ADDENDUM NO. 7

DATE: March 22, 2021
FROM: City of Grand Junction Purchasing Division
TO: All Offerors
RE: Grand Junction Fire Department Fire Station #3 Construction IFB-4889-21-DH

C2-0

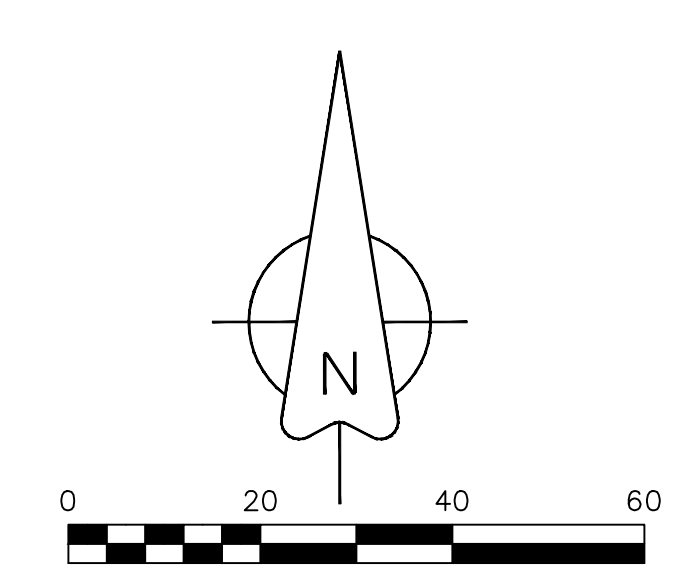
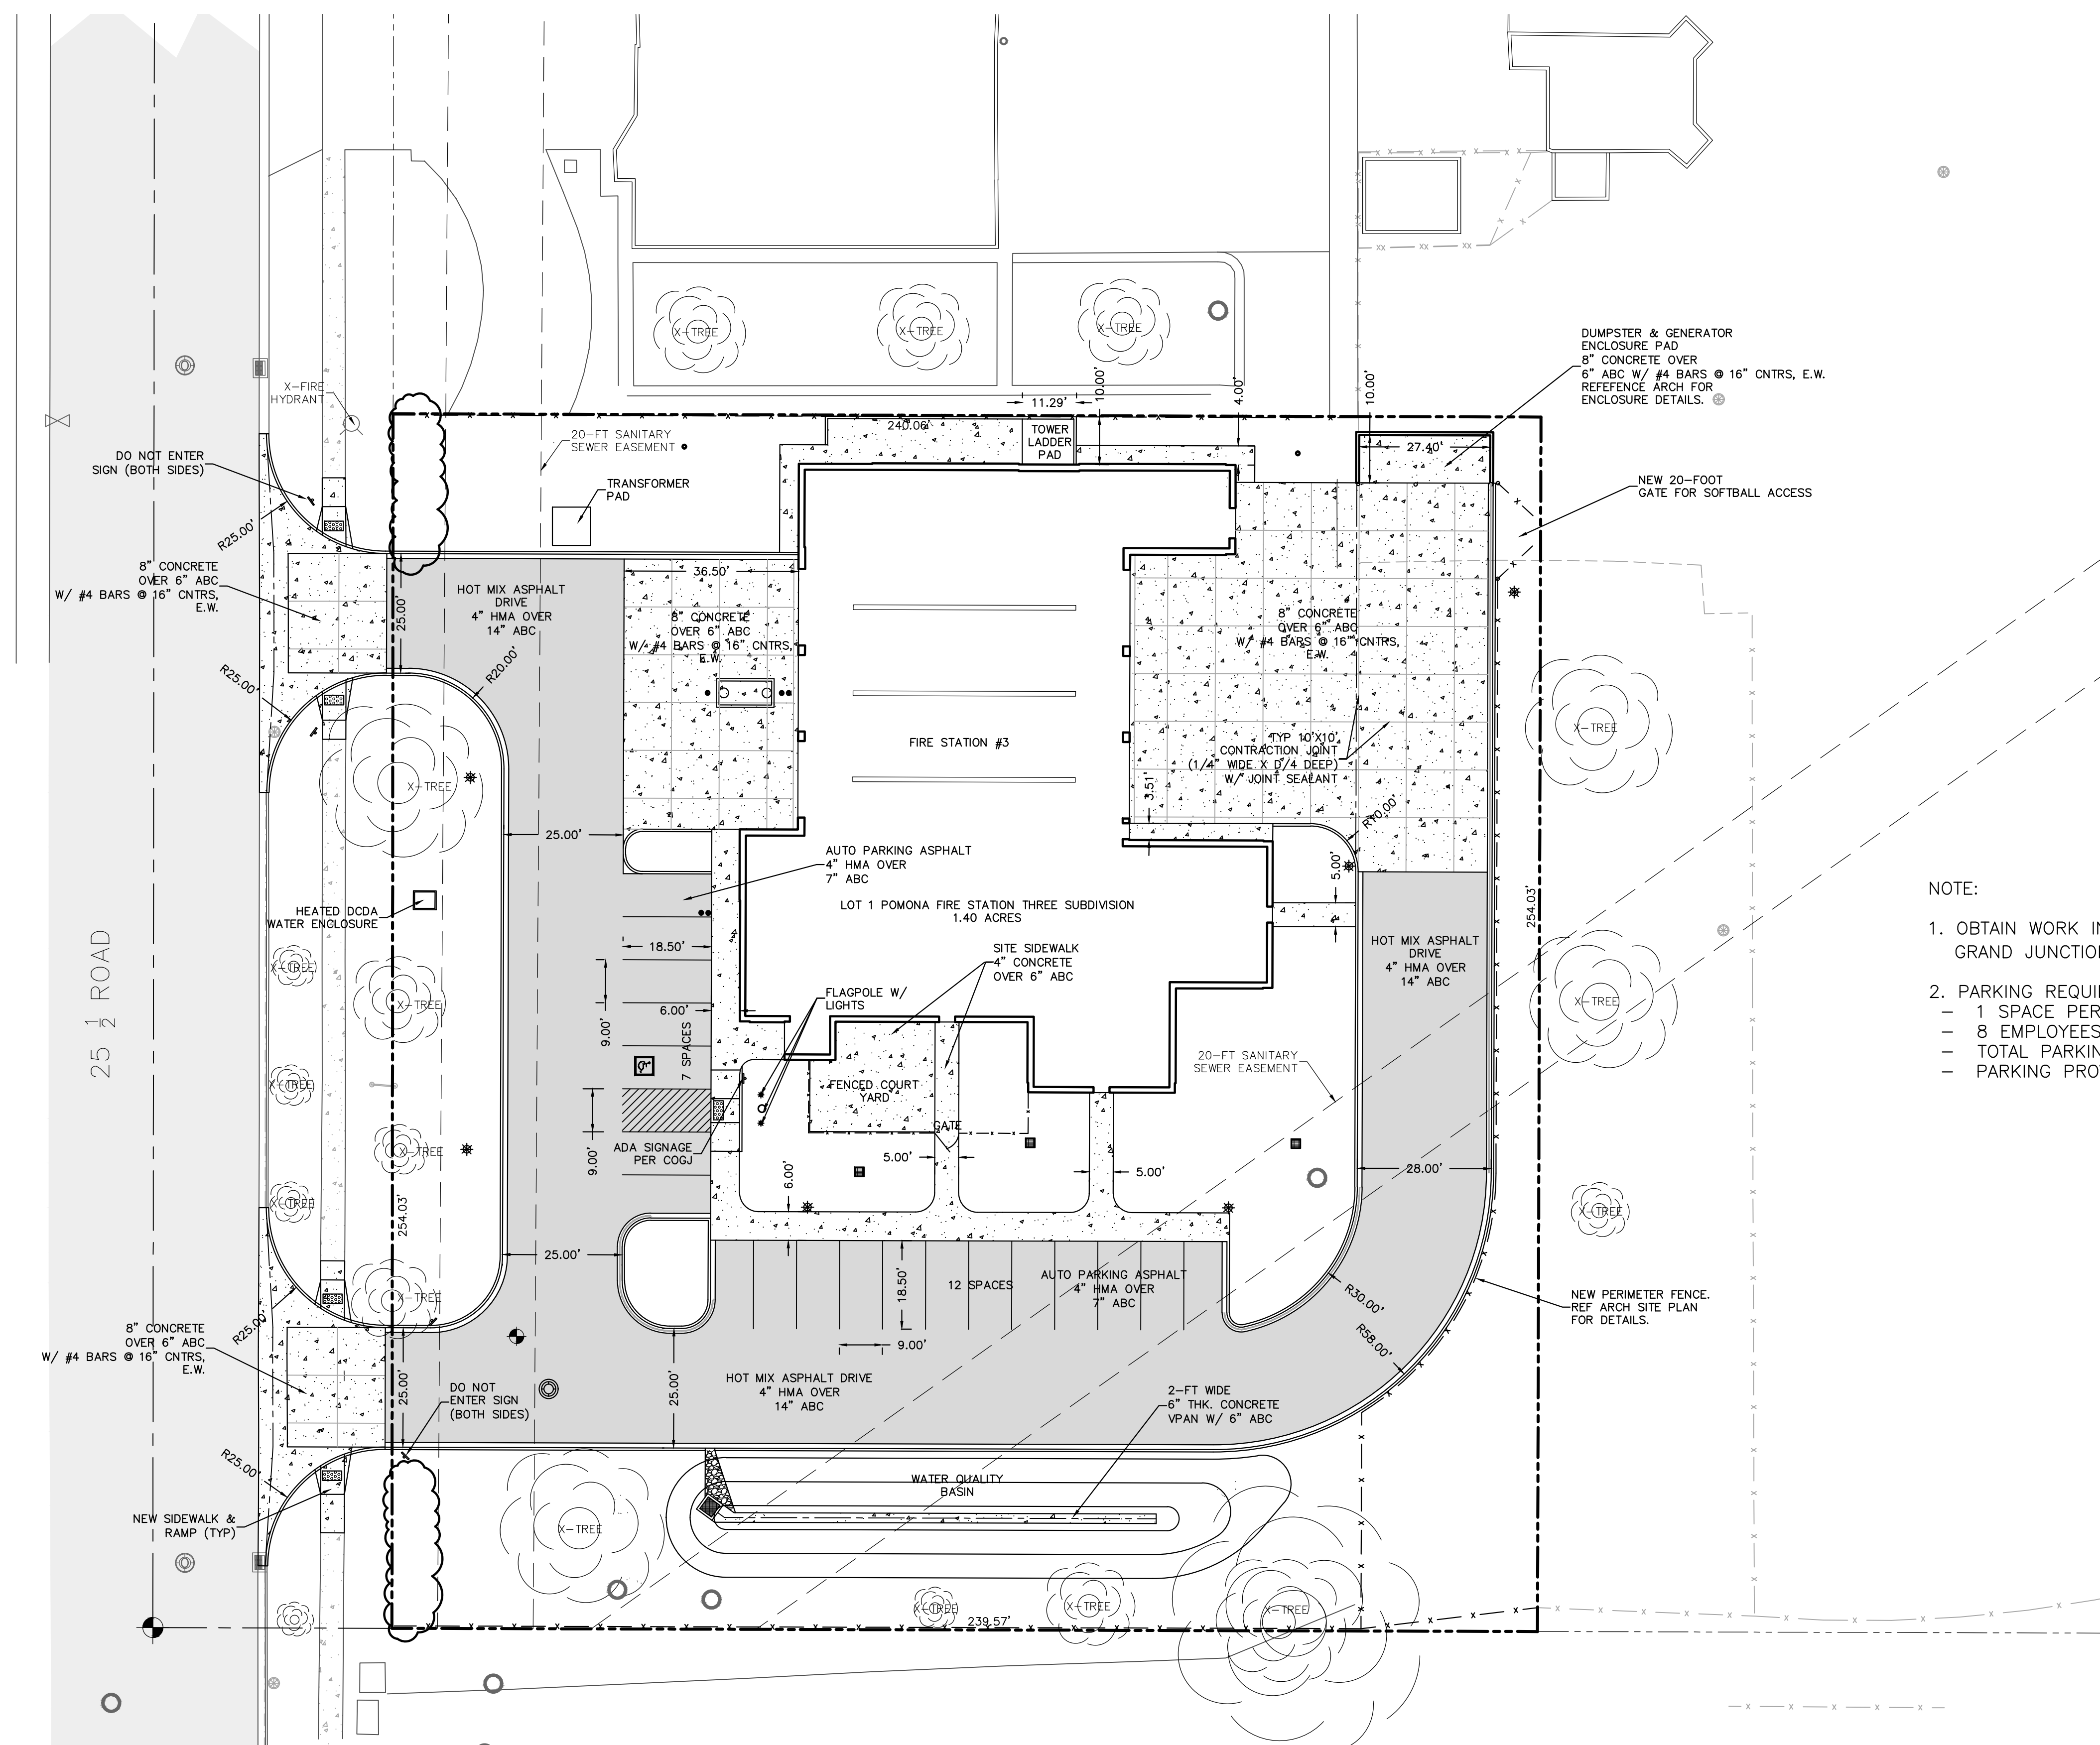
21. Access to Existing Fire Station: Access to the back of the existing Fire Station during construction may require demo of some landscaping North of the limits of construction. Is this acceptable?

- A. The existing trees along the south side of the existing fire station shall be protected, as well as any existing utilities in this area. Contractor may demo some landscaping north of the existing parking - contractor to coordinate irrigation shutoff with GJ Parks. Successful bidder shall coordinate with Owner for extent of required demolition and protection of existing trees. Refer to updated sheet C2-0.

C6-0

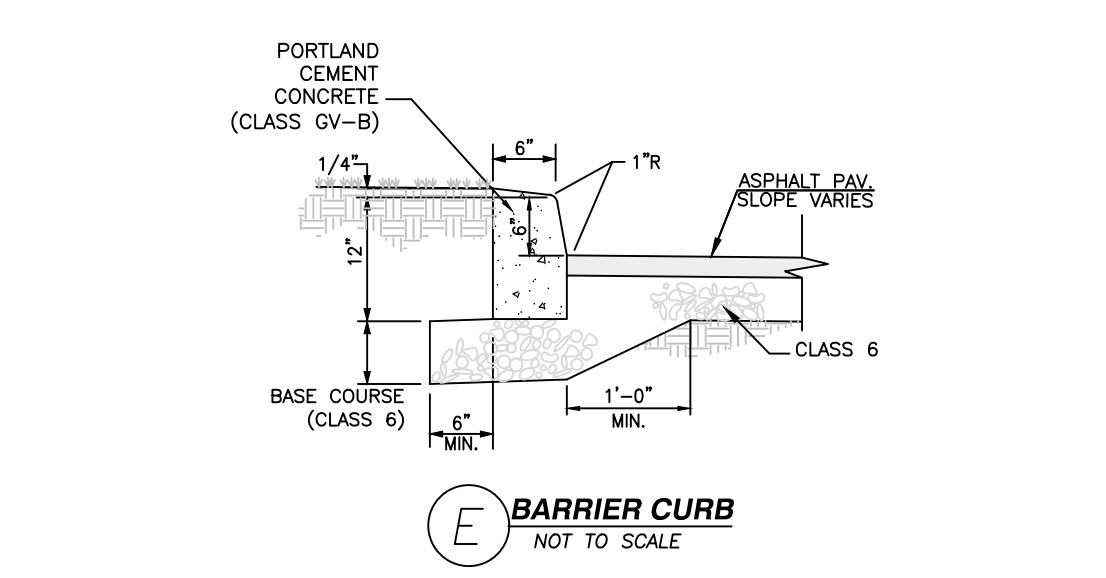
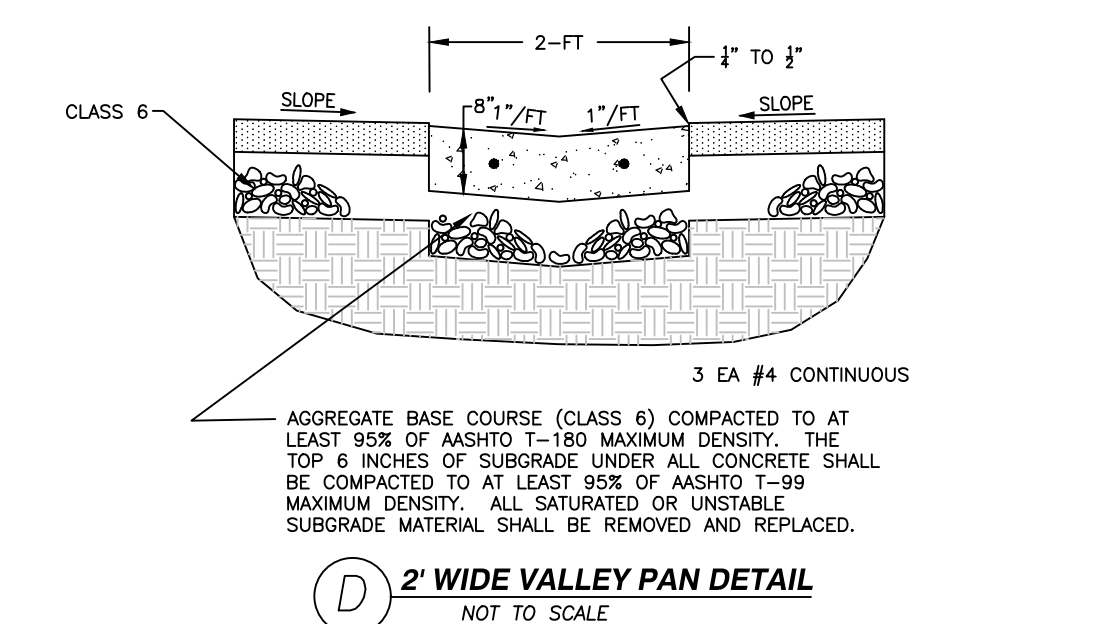
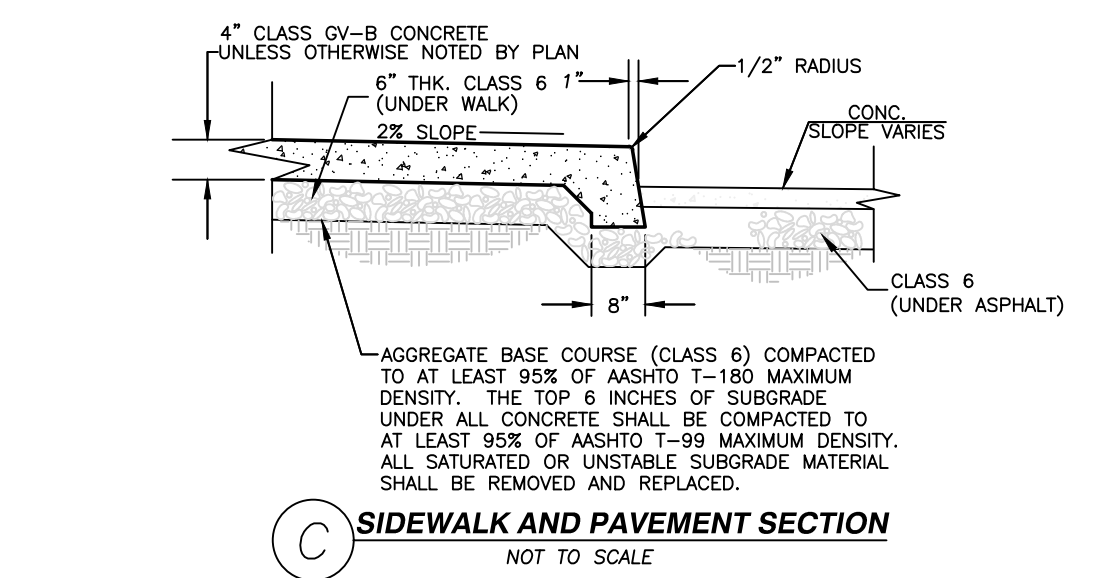
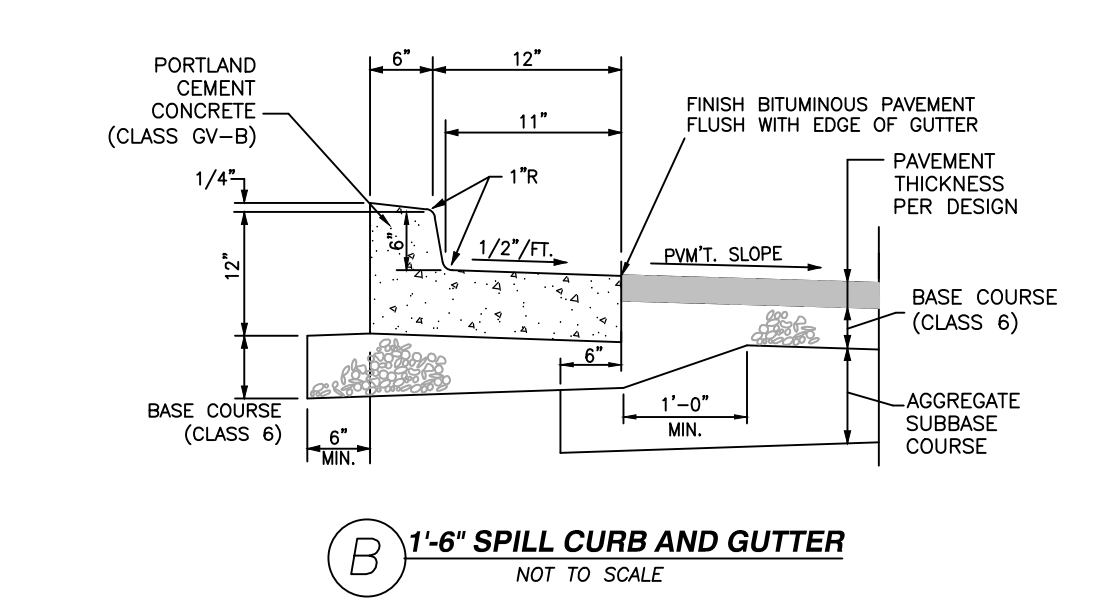
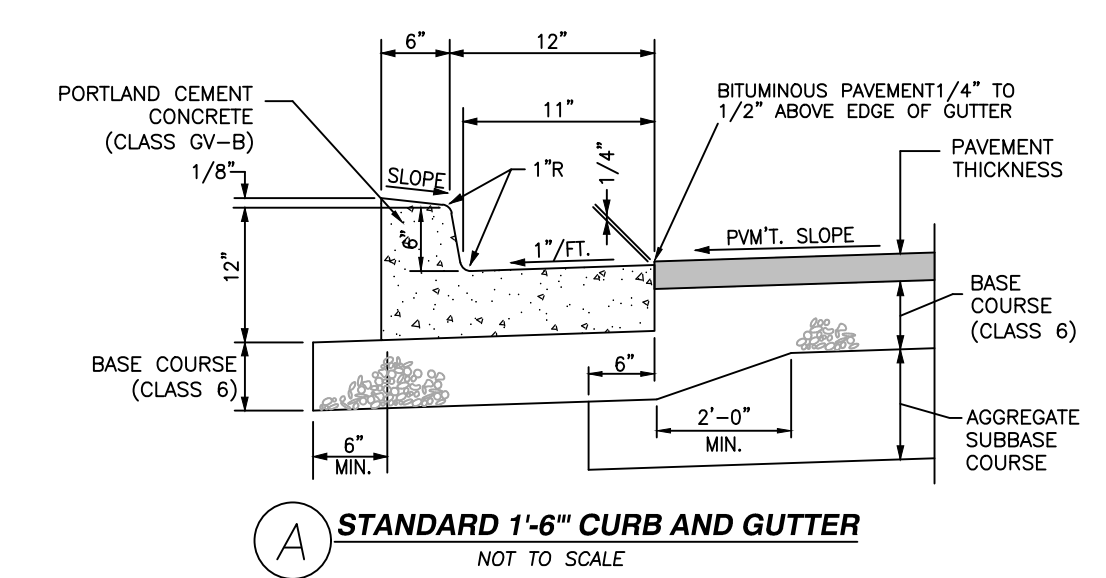
1. Drawings C3-0 & C6-0: The "V" Pan in the Water Quality Basin is dimensioned at 2.00' on C3-0 and C6-0, but Detail D on C6-0 calls for the pan to be 3.00'. Please clarify.

- A. The Vpan detail on C6-0 has been changed to 2-ft wide. Please see attached revised sheet C6-0.
2. Drawings AS1-1 & C3-0: On AS1-1 The 6' Decorative Fence (10-9) terminates at the West side of the South run, but on C3-0 the fence shows a turn to the North. Which is correct? On AS1-1 the 6' Decorative Fence (10-9) terminates at the West side of the North run, but on C3-0 the fenced shows a turn to the South. Which is correct?
